NOTE: NEW MOUNTING DIMENSIONS FOR GEN5 GATE!

<small>TOLERANCE UNLESS OTHERWISE NOTED</small> 1 PLACE DECIMAL = ±.050 2 PLACE DECIMAL = ±.005 3 PLACE DECIMAL = ±.000		ANTHONY LIFTGATES, INC. CONFIDENTIAL PROPERTY OF 1037 W. HOWARD ST. PONTIAC, IL. 61764	
PART NAME: MTU-GLR-3000-A-G (102X12 XD, GEN5)		SCALE: 1 / 4	C
MATERIAL:		DR. BY: JUSTUS	
FINISH:		DATE: 3/6/2025	
HT. TREAT:		NO. REQ'D:	
COMMERCIAL STOCK SIZES ACCEPTED DO NOT SCALE DRAWING			
NEXT ASSY:		PART NO. MTU-GLR-3000-A-G	GEN5

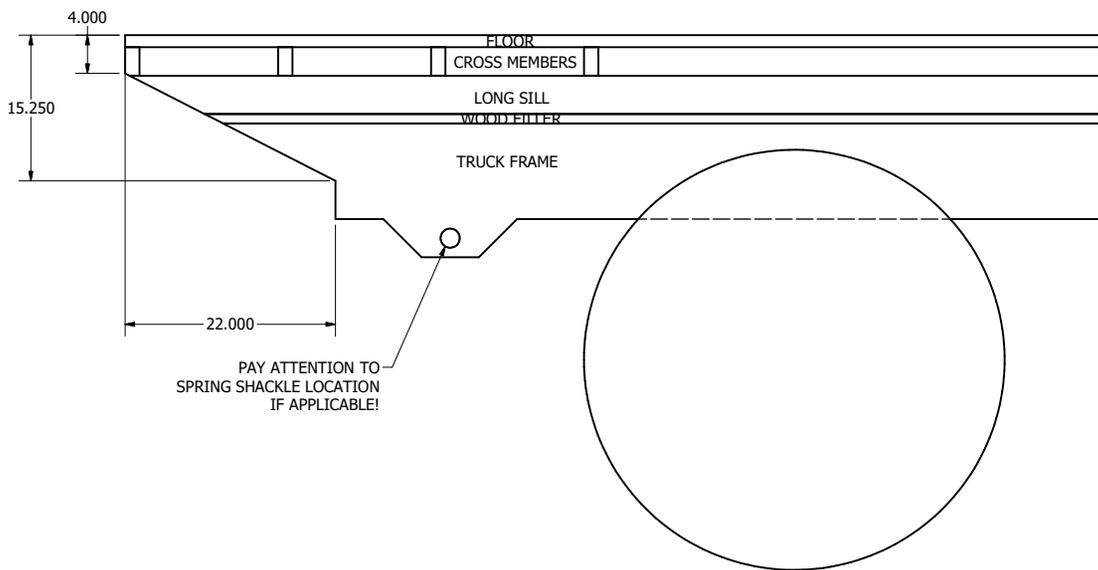
DUE TO COMPLETELY NEW GEOMETRY, THE MOUNTING LOCATION OF THE ADAPTER FRAME TUBE RELATIVE TO THE REAR SILL OF THE TRUCK HAS MOVED.

ALSO, MOUNTING DIMENSIONS FOR THE MTU ARE DIFFERENT FROM MTU-L, MTU-M AND MTU-HR DUE TO ARM LENGTH DIFFERENCES.

GATE:	ARM LEN.	BED RANGE	GRND CLRNC
MTU25/3	36.313"	46"-56"	13.875"-23.875"
